**ADDENDUM 2**

RE: **IM 0907(93)310, Aurora County – PCN 09P1**  
**Road Closure Gates on I90 at Exit 310 (US281)**

# OVERVIEW I90 & US HWY 281

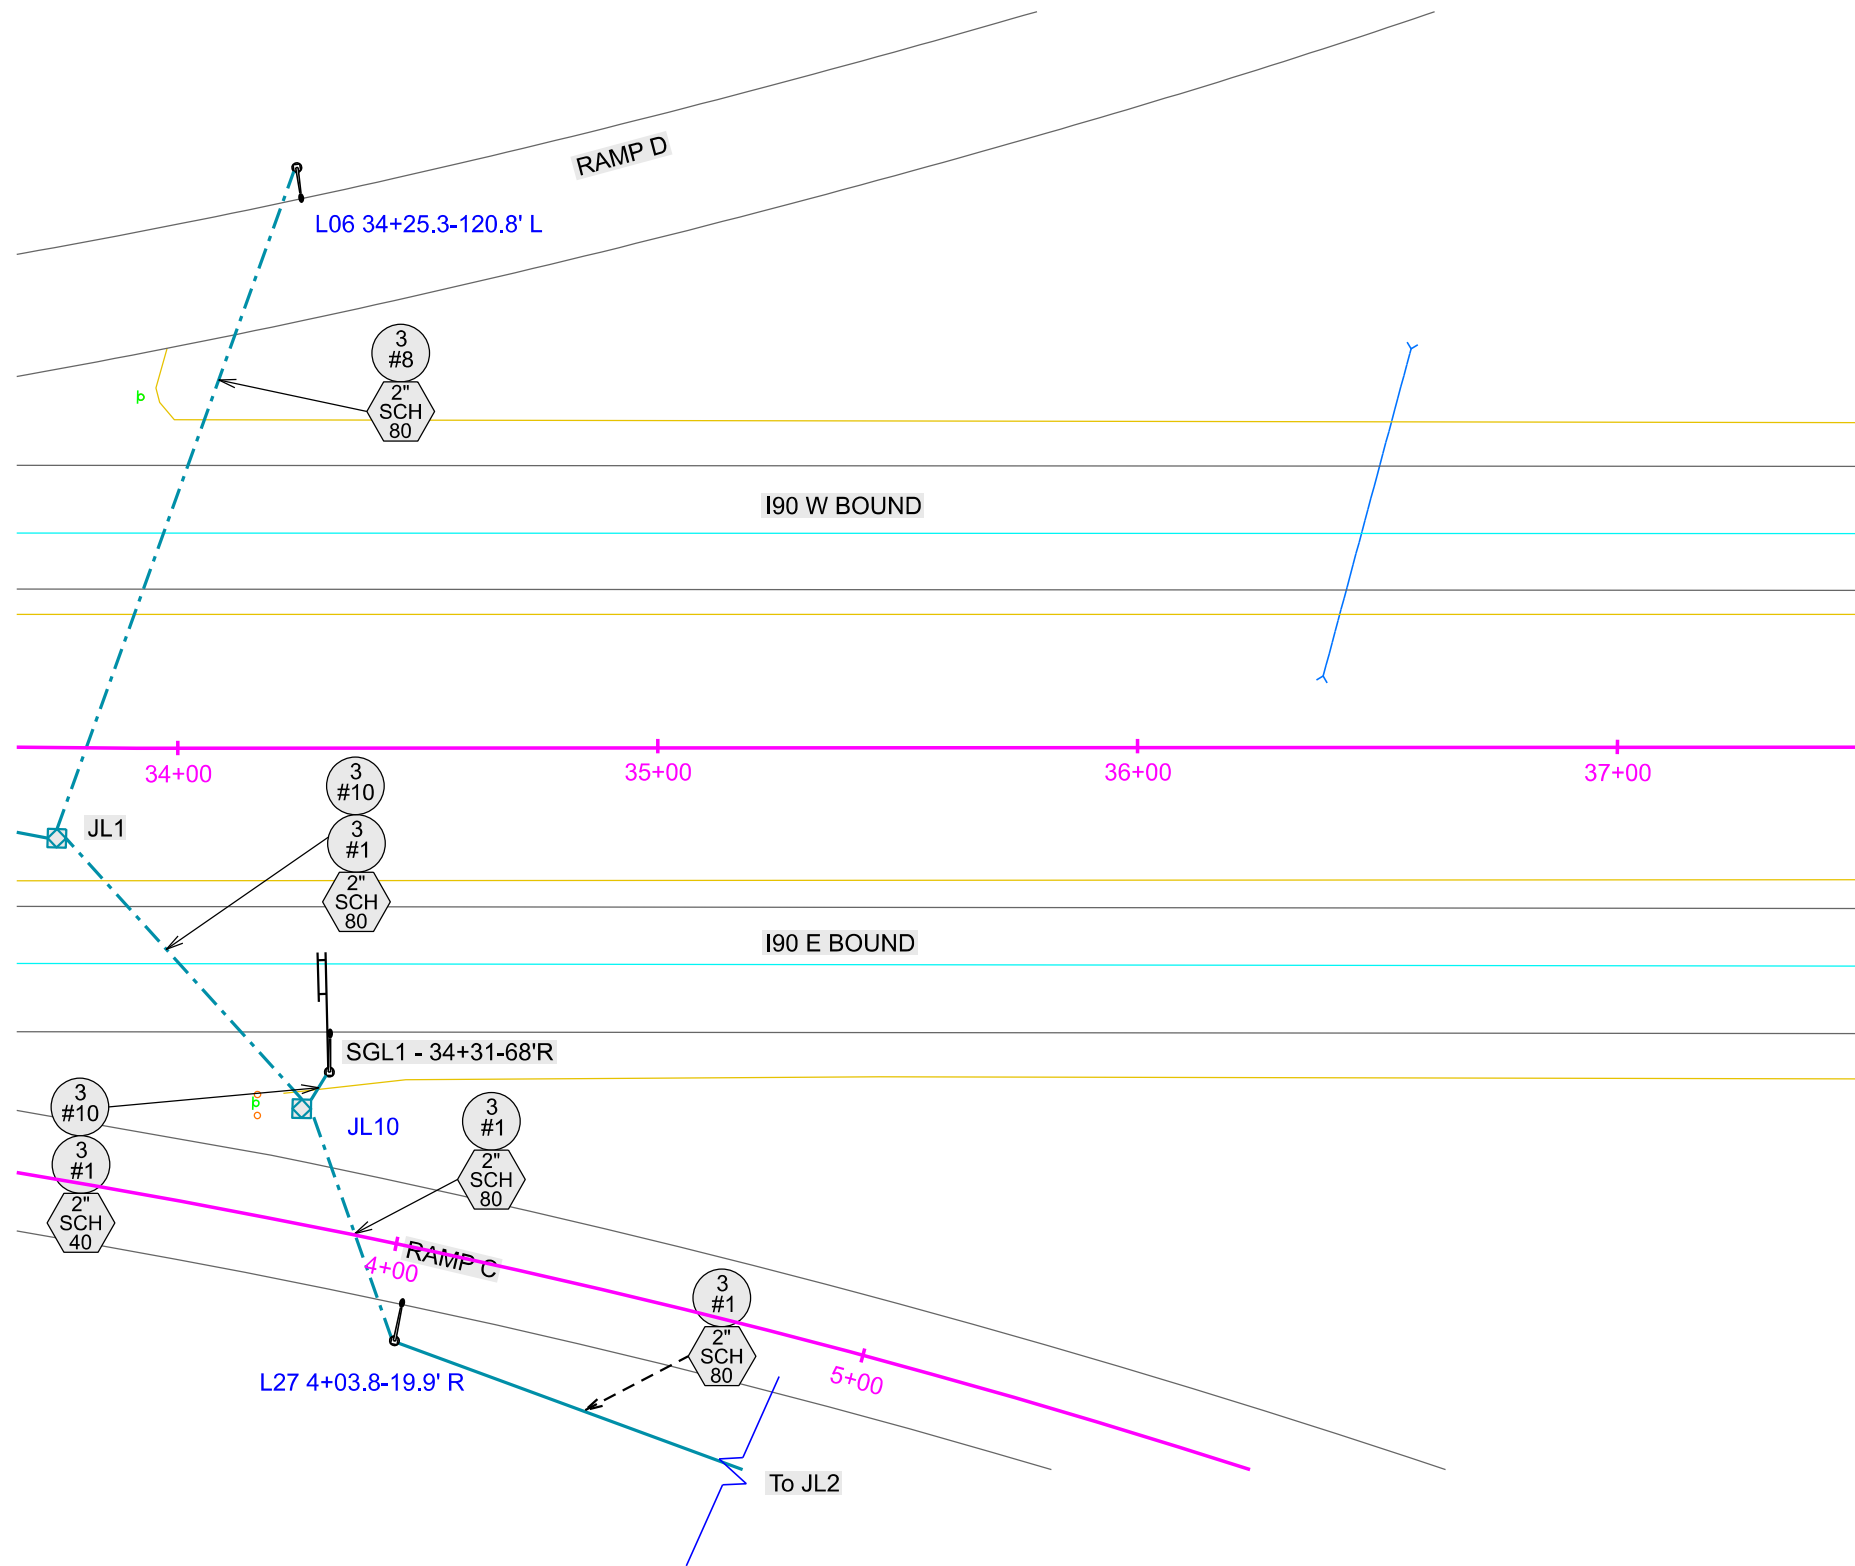
Sheet	Revision	Date
2	Change to Quantities: -635E0050 Breakaway Base Luminaire Pole with Arm, 50' Mounting Height, increased 16 to 18 -635E5020 2' Diameter Footing increase 258 to 274 -635E5301 Type 1 Electrical Junction Box, increased from 15 to 17 -635E8120 2" Rigid Conduit, Schedule 40, increased 11175 to 11190 -635E8220 2" Rigid Conduit, Schedule 80, increased from 1290 to 1305 -635E9011 1/C #1 AWG Copper Wire, increased 9145 to 9165 -635E9010 1/C #0 AWG Copper Wire, increased from 6920 to 7000 -635E9020 1/C #10 AWG Copper Wire, increased from 19875 to 19975 -635E9710 2/C #10 AWG Copper Pole and Bracket Cable, decreased from 2990 to 2710	8-5-2024 - RR
4	Revised Plan note for "Luminaires", and "Table of Footing Data"	8-5-2024 - RR
18-19	Revised tables to reflect addition of Luminaire Poles L27 and L28	8-5-2024 - RR
20	Changes to plan Overview	8-5-2024 - RR
21	Revised EOQ table	8-5-2024 - RR

SD DOT	PROJECT	SECTION	SHEET
	IM 0907(93)310	Non	26 of 62

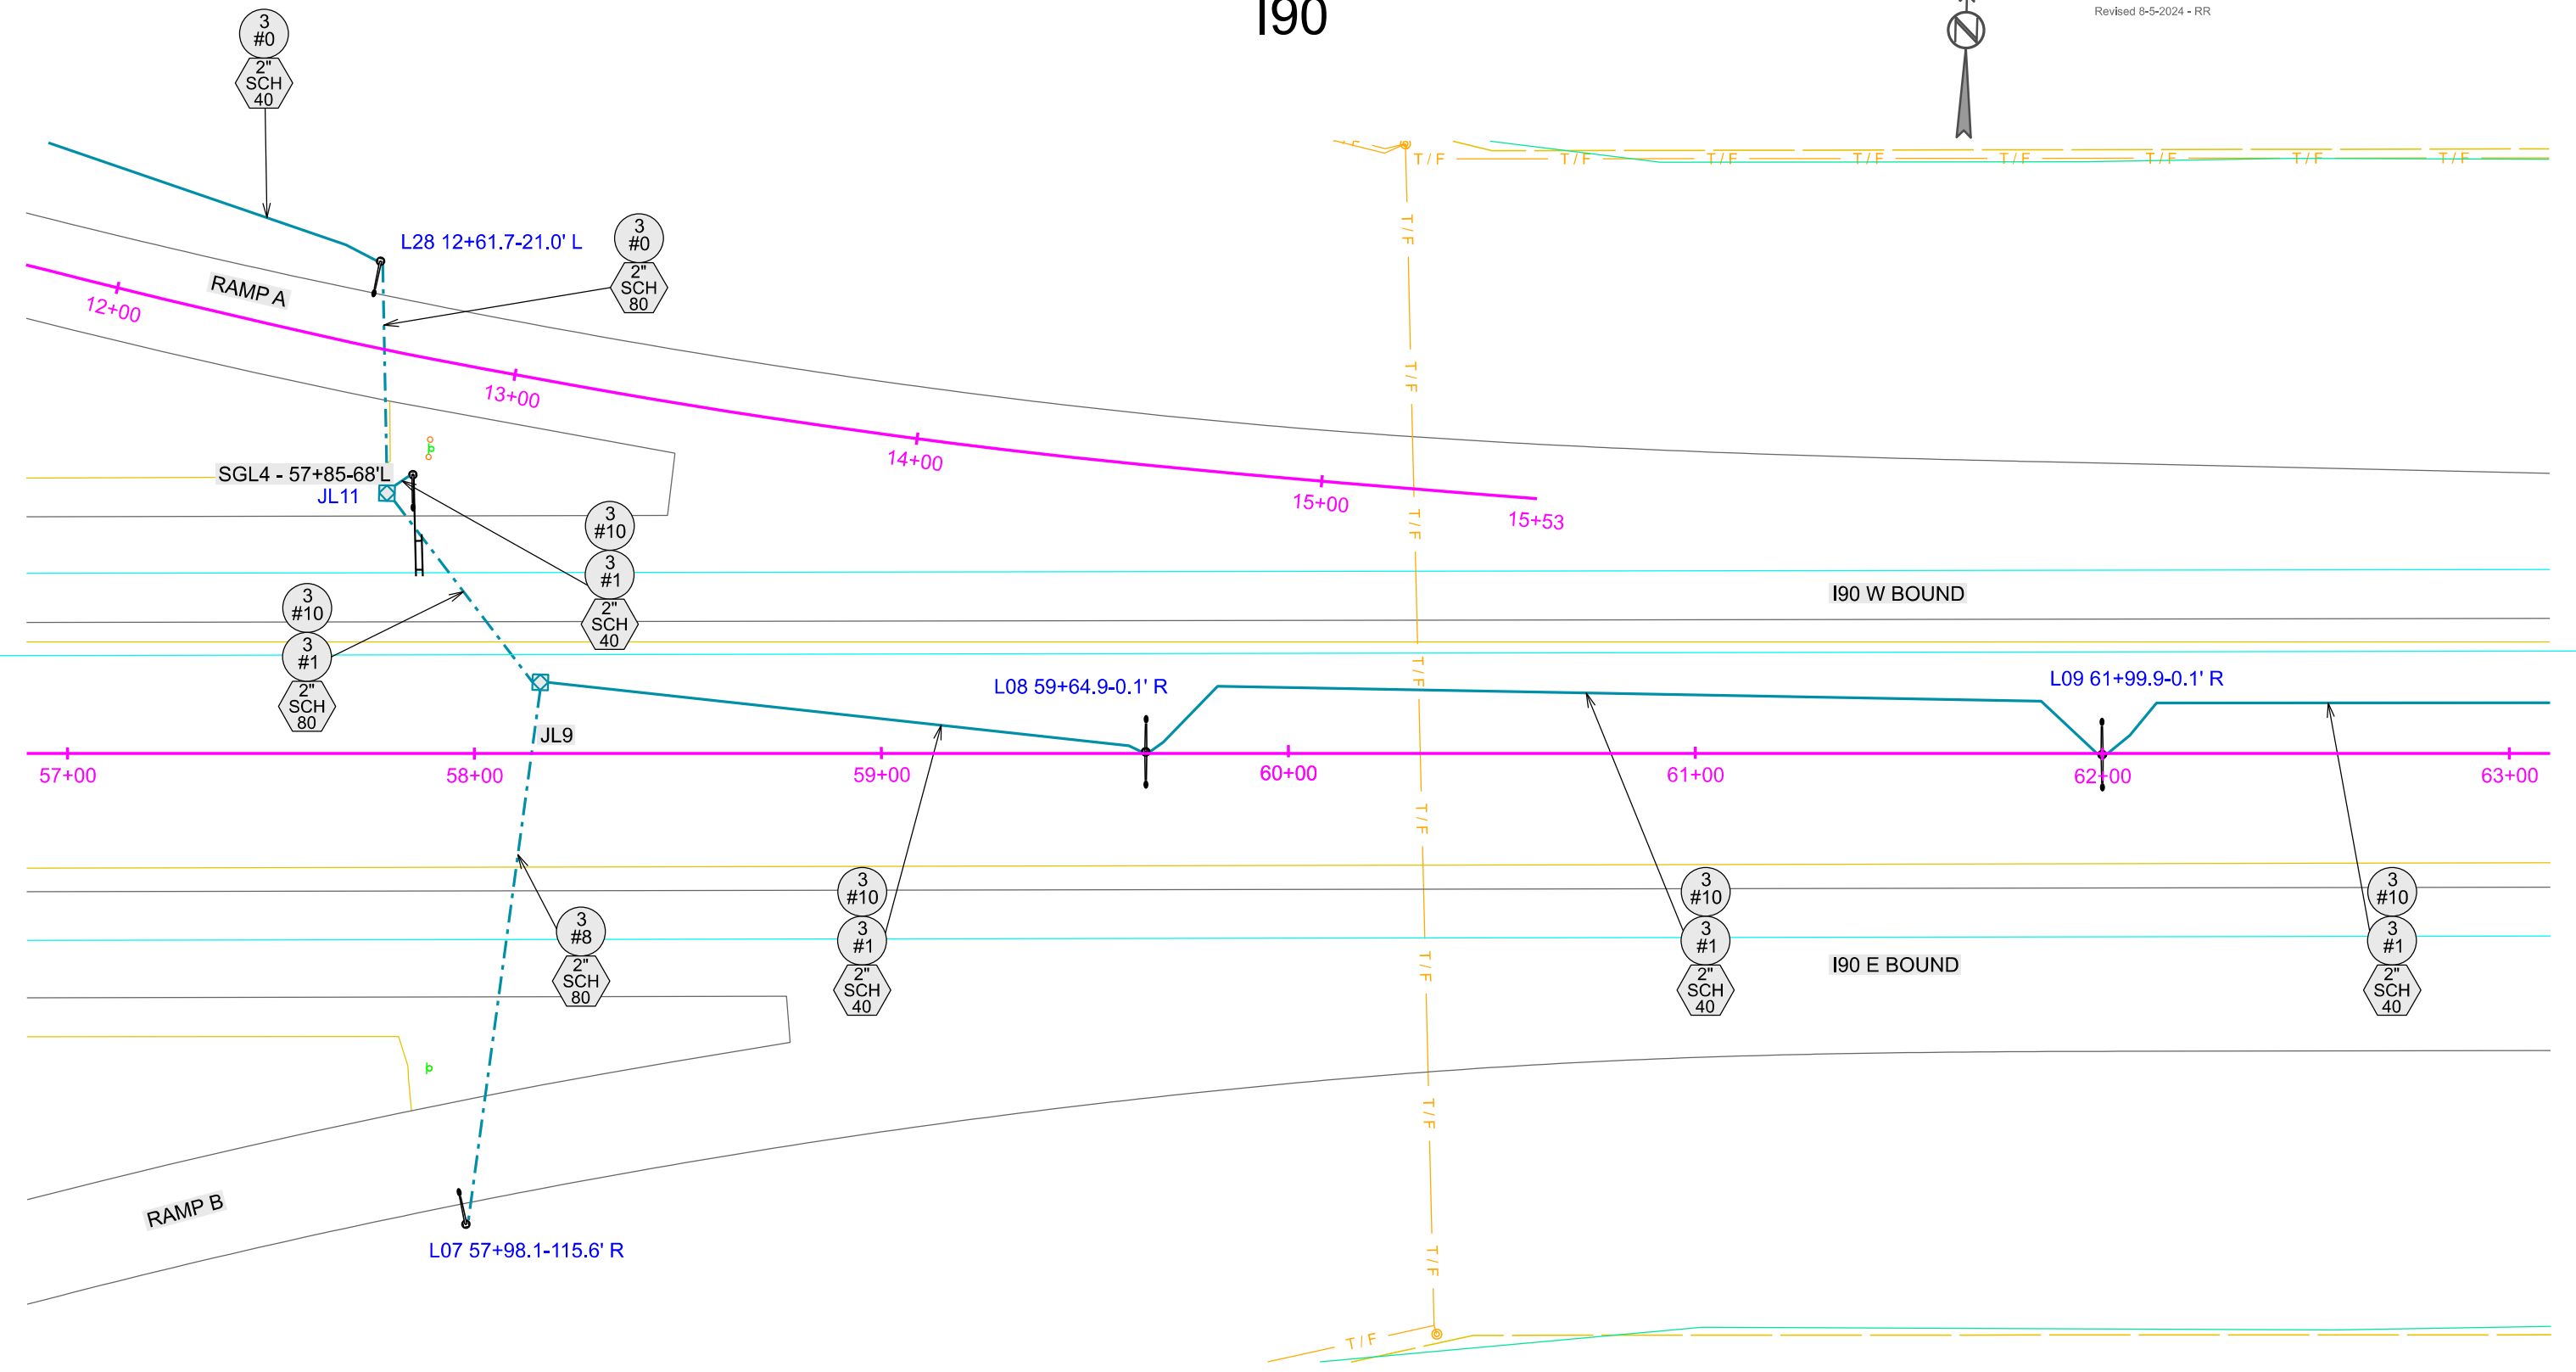
26,27,39,40	Changes to wire call outs, change of pole name labels, SGL1 and SGL4 changed from 50' twin arm pole to 40' single arm pole, Added Pole L27 and L28.	8-5-2024 - RR
43-44	Addition of poles to wiring diagrams, change of pole name labels	8-5-2024 - RR
47-48	Special Detail for Closure Gates changed to show single arm with 40' Mounting Height Poles	8-5-2024 - RR
